**WORCESTER TOWNSHIP PLANNING COMMISSION MEETING
WORCESTER TOWNSHIP COMMUNITY HALL
1031 VALLEY FORGE ROAD, WORCESTER, PA 19490
THURSDAY, FEBRUARY 13, 6:30 PM**

Reference: 2578 Morris Road – Minor Subdivision Plan

Reference: 2578 Morris Road - Revised Minor Subdivision Plan

RE: **Traffic Review #1 – Minor Residential (Two-Lot) Subdivision Plans**
2578 Morris Road
Worcester Township, Montgomery County, PA
McMahon Project No. 820008.11

EXISTING SITE PLAN
 MINOR PLAN
 2 LOT RESIDENTIAL SUBDIVISION
 PROPERTY OF
MAZZ PROPERTIES, LLC
 2578 MORRIS ROAD
 State: PA
 The Township of Worcester
 Montgomery County, Pennsylvania

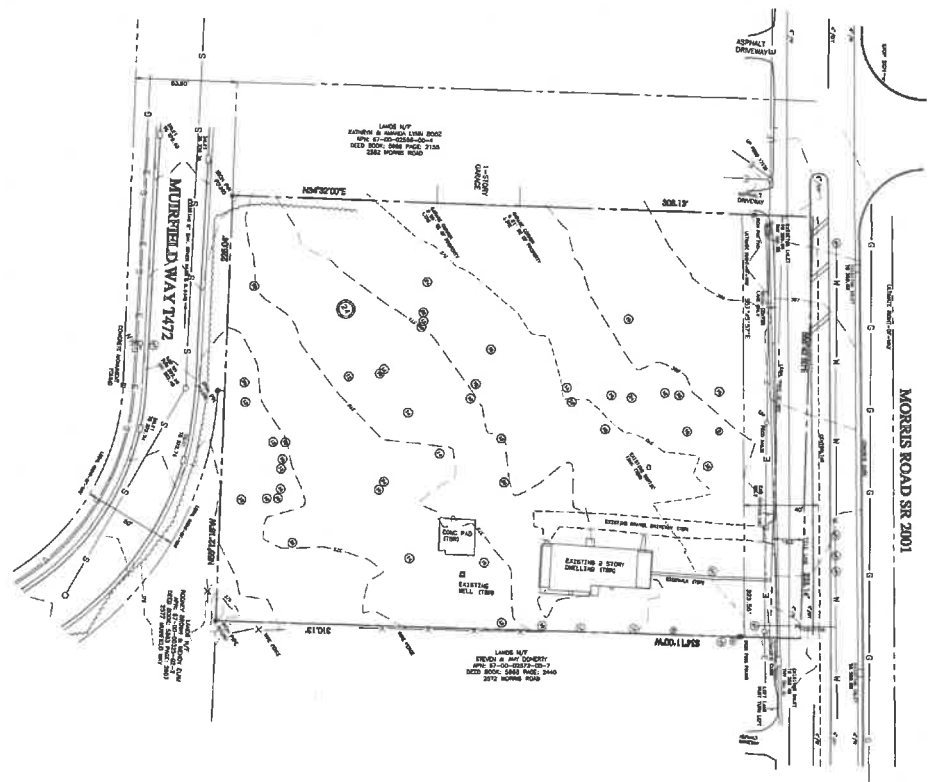
13. Sheet 2 of 6 is entitled "Existing Site Plan". These plans show the existing dwelling on the property as well as all other existing features including all trees and wooded areas. A site visit to the property on December 3, 2020 has found that the entire property has been clear cut of all vegetation with the exception of one (1) tree. Attached to this letter are several pictures showing the condition of the site as of December 3rd. Therefore, the existing site plan is not accurate at this point. (See the attached photographs). The existing site plan did

- show the location of all trees over 6" caliper and specifically designated those trees "to be removed". Unfortunately, all of the trees and wooded areas have been removed. The applicant must prepare a separate landscape plan to fully comply with Section 130-28 of Township Code (Landscaping). Specifically, the applicant should comply with Section 130-28.F (7). Also, perimeter buffers must be added to both sides of the property and a screening buffer should be added at the rear of the property, adjacent to the to the AGR Zoning district.

13. Existing Site Plan

We acknowledge that the existing vegetation on the site was cleared sometime following our initial plan submissions and as such returned to the site to locate the removed trees and update the existing site plan.

**PROPOSED IMPROVEMENTS AND
STORMWATER OPERATIONS AND
MAINTENANCE PLAN**

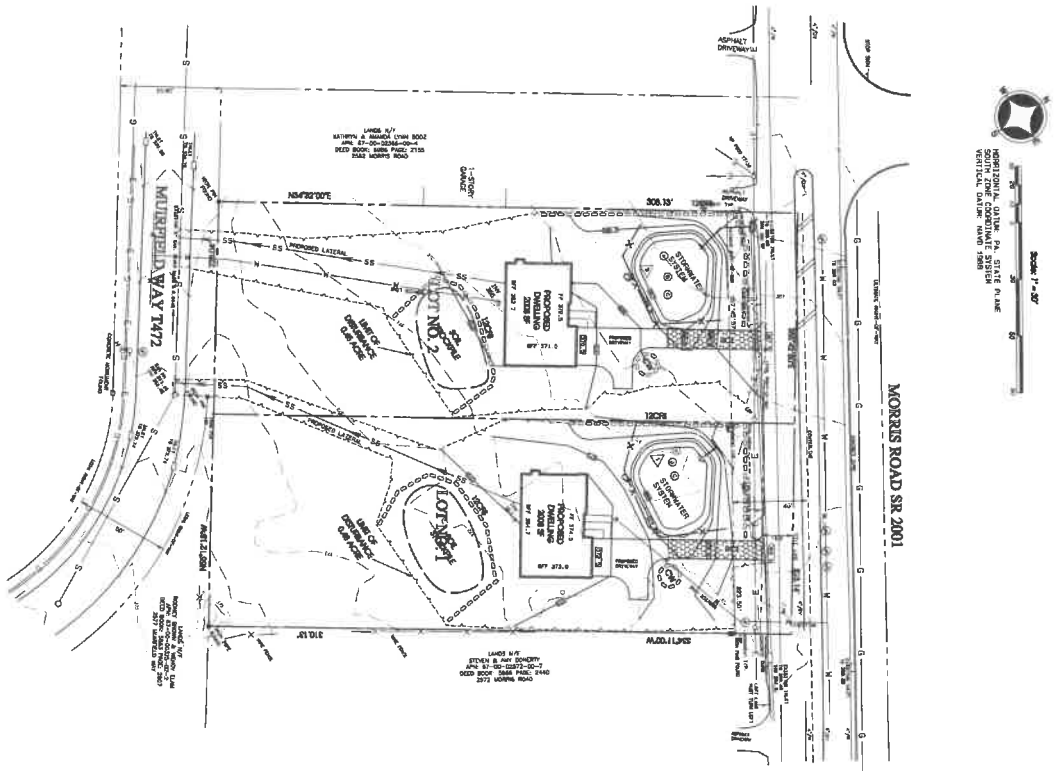
16. In conjunction with Stormwater Management Design and Plans, there are few concerns with the locations of the proposed outlets from the rain garden. The discharge pipe for the rain garden on Lot 2 is directed at the front of the adjacent property and the existing asphalt driveway. There is a storm inlet directly in front of Lot 2 which could accommodate a direct connection from the rain garden discharge pipe. I would suggest that the discharge pipe connect directly to the outlet or be relocated away from the adjacent property and driveway. In addition, the outlet discharge pipe from the rain garden on Lot 1 is directed at Morris road. Again, it is suggested that this pipe connect directly to the storm pipe along the front of the property. Section 129.12Q requires that any stormwater discharge directly onto a State Road must be approved by PennDOT. Since both of these rain gardens are discharging directly to Morris Road, the applicant should submit the stormwater plans to PennDOT for their review and approval.

Based on the information provided in the Proposed Improvements and Stormwater Operations and Maintenance Plan (Sheet 4), it appears that each of the dwelling units would have a stormwater management facility (rain garden) in the front yard. We recommend that on the deed it be noted that the rain gardens shall be inspected and maintained, and that the applicant provide a maintenance guide for the homeowner to ensure that they continue to function properly.

Based on the Engineer's concerns, we have revised the plans to indicate a "hard connection" of the system on Lot no. 2 to the Penn DOT inlet and have re-positioned the level spreader discharge on Lot no. 1 to provide positive flow to the inlet. We are currently in the process of permitting the direct connection to the inlet with Penn DOT and will provide a copy of the permit upon receipt.

SEDIMENT EROSION CONTROL PLAN

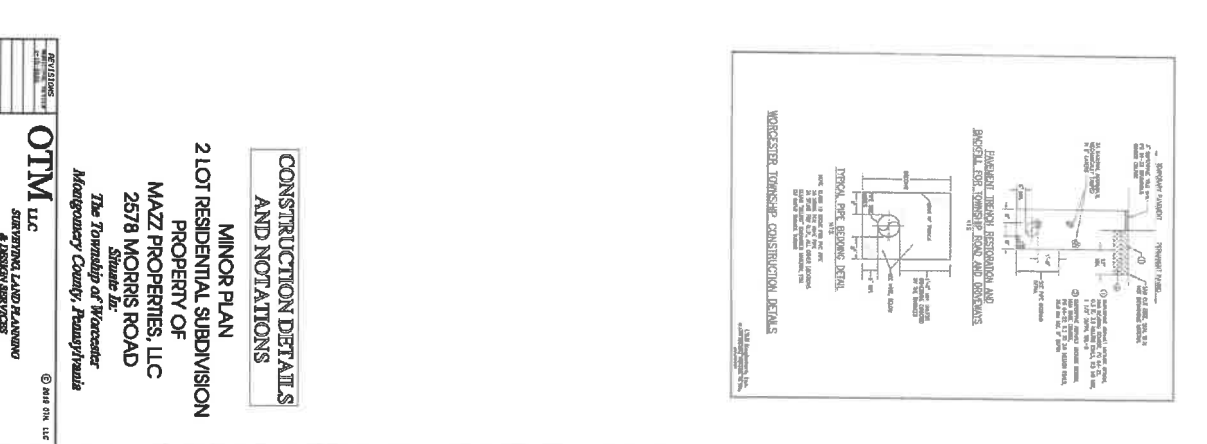
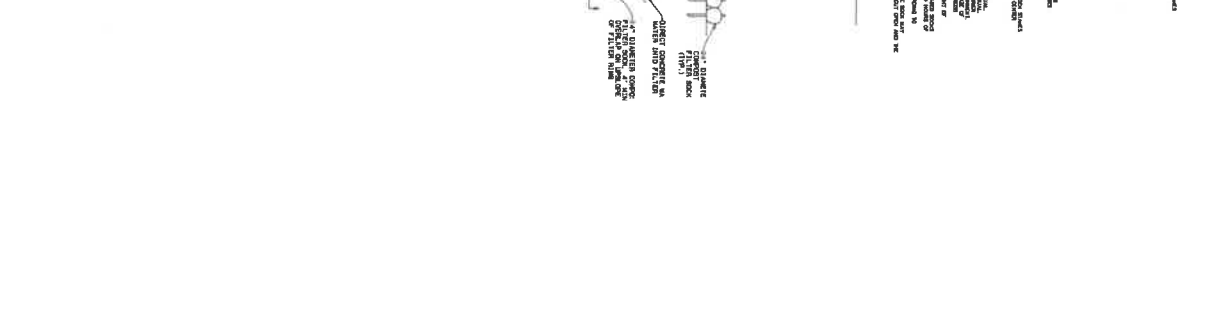
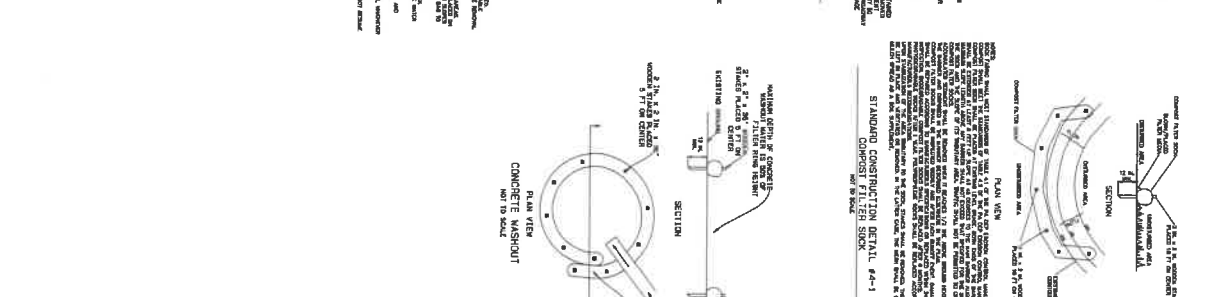
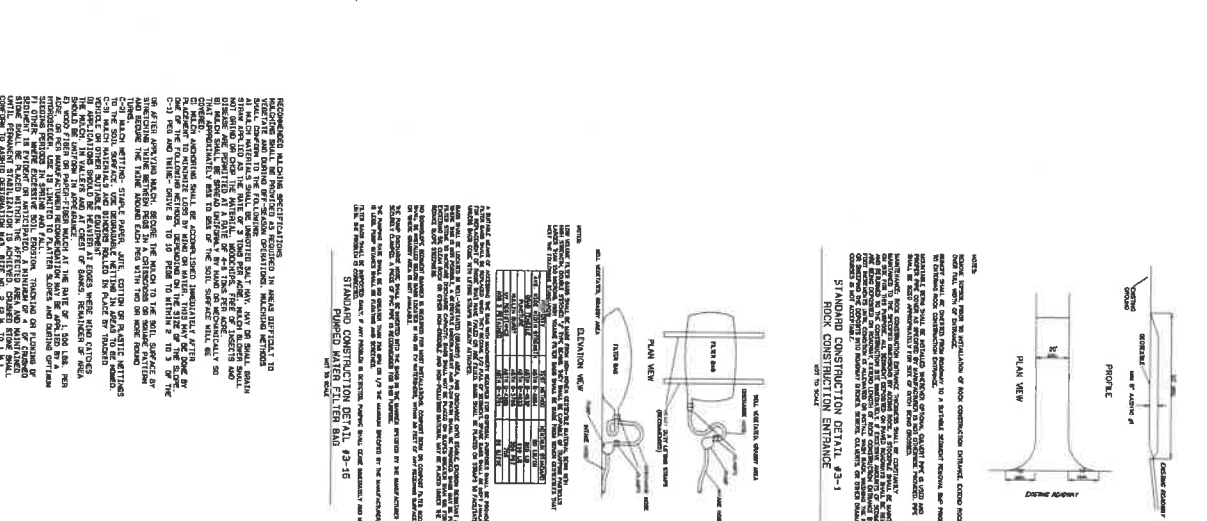
14. Sheet 5 is entitled "Sediment Erosion Control Plan". This plan also shows the limits of disturbance on each lot. Quite frankly, at this point, the entire lot has been disturbed by the removal of the wooded area and the trees that have been removed from the site. The limits of disturbance on sheet 5 should be revised to reflect the actual site conditions. If this total limit of disturbance is over one (1) acre (for the one existing lot), then the applicant will be required to obtain an NPDES Permit.

18. Sheet No. 5 includes a "Construction Sequence". This construction sequence needs to be revised to reflect what has actually occurred on the property. Items 1 and 2 clearly were not

done, and item 4 regarding the cleaning and removal of vegetation was not followed, since areas beyond the limits of disturbance have also been cleared. The construction sequence should therefore be revised accordingly.

As such, I have discussed this situation with the owners and they have agreed that during construction of the dwellings, that any and all "earth disturbance" would be limited to those areas as outlined on the sediment erosion control plan and that any work outside of those limits would be limited to raking, over seeding, grinding of stumps (if necessary) and planting of required landscaping.

LANDSCAPE PLAN
 SCALE: 1" = 20'-0"
 SEE SHEET LP-2 FOR PLANT SCHEDULE & DETAILS

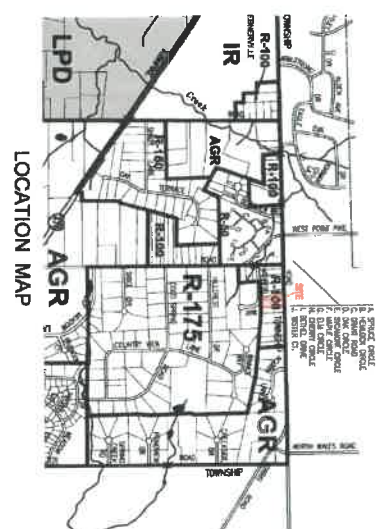
7. The latest set of plans have included a landscaping plan which shows the required replacement trees on the property, as well as the buffering required around the perimeter of the property. There is one change that needs to be made to the landscape table on the plans. My original review indicated that a screening buffer would be required along the rear of the property. This buffer should be installed in accordance with Section 130-28G(5)(f) of the Township ordinance. This is required due to the

difference in zoning district classifications of the two abutting properties. The screening buffer should include more evergreen plantings to provide an immediate visual buffer between the two (2) zoning districts. The landscape plan should be revised to provide the screening buffer along the rear property lines.
